Access Compliance Report

Public Rights-of-Way

Intersection ID: 28345	Main Street: BACARDI_CT	Cross Street: HIRSCH_DR	Location: SE
ADA ID: CD2A5B354039	Ramp Type: Perp	Initial Pass/Fail: Fail	Overall Compliance: No
		Severity Score: 8.75

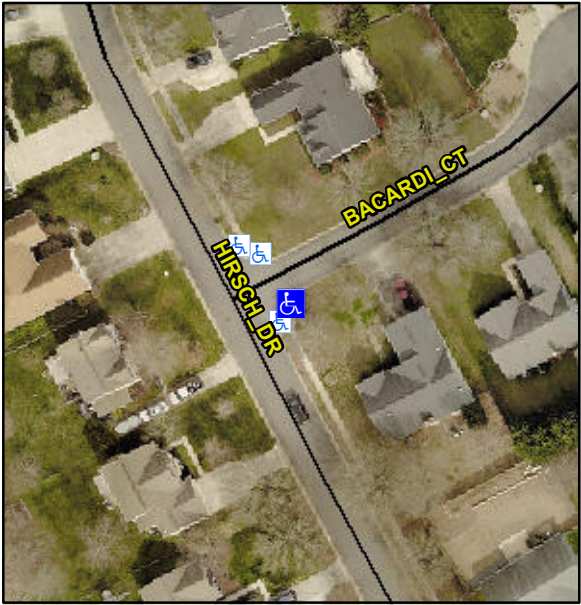
Codes/Mitigation Info/Possible Solution			Field Measurements/Component Compliance		
	Possible Solutions:		Compliance	Description	Data
	Remove & Replace Entire Ramp.		Yes	Ramp Length (in)	93.0
			No	Ramp Width (in)	47.0
			N/A	Flare Type LT	N/A
			N/A	Flare Slope LT (%)	N/A
			N/A	Flare Traversable LT?	N/A
			N/A	Landing Length (in)	N/A
			N/A	Landing Width (in)	N/A
			N/A	Landing Slope (%)	N/A
			N/A	Landing X Slope (%)	N/A
<p>Surveyor Notes:</p> <p>N/A</p> <p>PROW/ADA:</p> <p>Not Found, R304.5.1</p>			N/A	Landing Curb? (Y/N)	N/A
			N/A	Shared Landing?	N/A
			N/A	Gutter Ponding?	N/A
			N/A	Gutter Lip Ht (in)	N/A
			N/A	Painted X Walk1?	No
				X Walk 1 Direction	To NW
			N/A	X Walk 1 Width (in)	N/A
				X Walk 1 Slope (%)	2.0
				X Walk 1 X Slope (%)	3.0
			N/A	Ramp inside XWalk1?	N/A
<p>Street 1 Name</p> <p>Stop Condition-Street 2</p> <p>Street 2 Name</p> <p>Stop Condition-Street 1</p>			N/A	Road Slope (%)	N/A
